IREDELL COUNTY HEALTH DEPARTMENT

IMPROVEMENT PERMIT / CERTIFICATE OF COMPLETION / OPERATION PERMIT / EXISTING SYSTEM INSPECTION

PROPERTY DESCRIPTION NO. 18560 DATE 6-27-94 TAX MAP NO. 8J-1-B-5 Watershed: ☐ Yes ☑ No

INITIAL SITE SKETCH

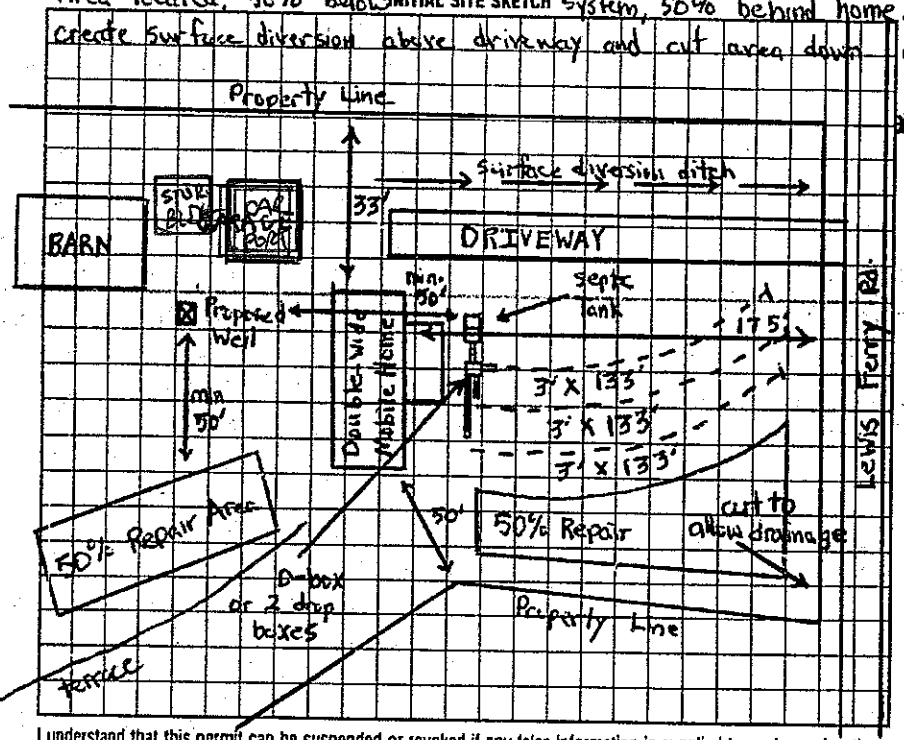
Comments: INSTALL SYSTEM SHALLOW (no deeper than 30" to trench bottom) Keep Lines and Trenches on contour. Keep system min. 5' from foundation of home, 10' from all property lines, and keep well 50' from Septic system and Repair Areas. Repair Area located, 50% below system, 50% behind home. Create surface diversion above driveway and cut areas down at corner of lot to allow proper drainage. * Do not cut or fill in area where drainfield is to be installed (1' of fill allowed)

AS BUILT SKETCH

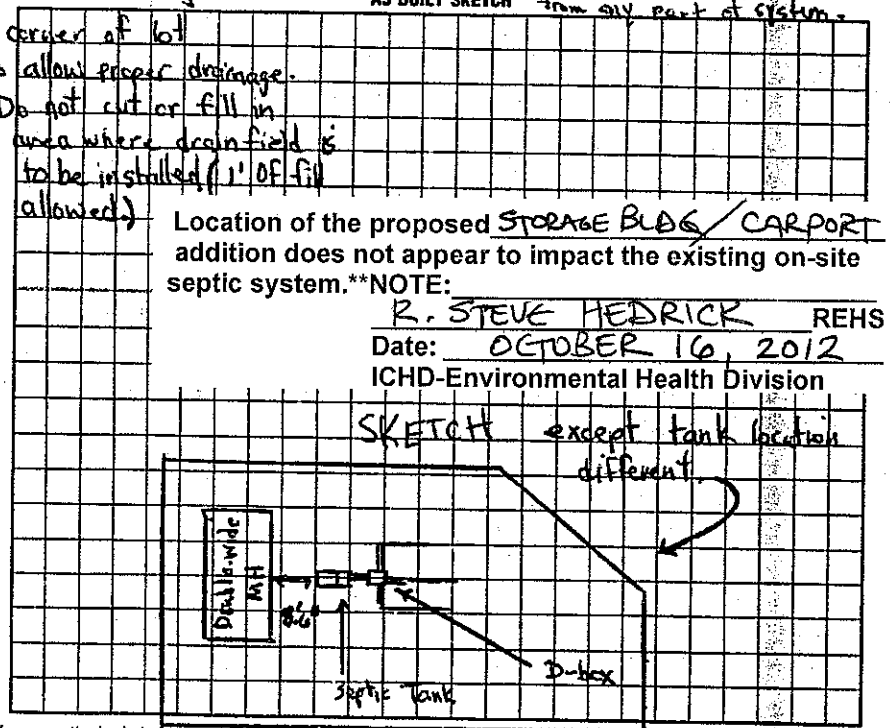
Comments: System checked 8-29-94. Surface diversion ditch and high area at Rd cut 9-19-94. Soil had relic mottling, may require interceptor drain if surface diversions does not correct [redacted] water drainage. Well located at the time of inspection, it is 50'+ from any part of system.

Location of the proposed STORAGE BLDG / CARPORT addition does not appear to impact the existing on-site septic system.**NOTE:
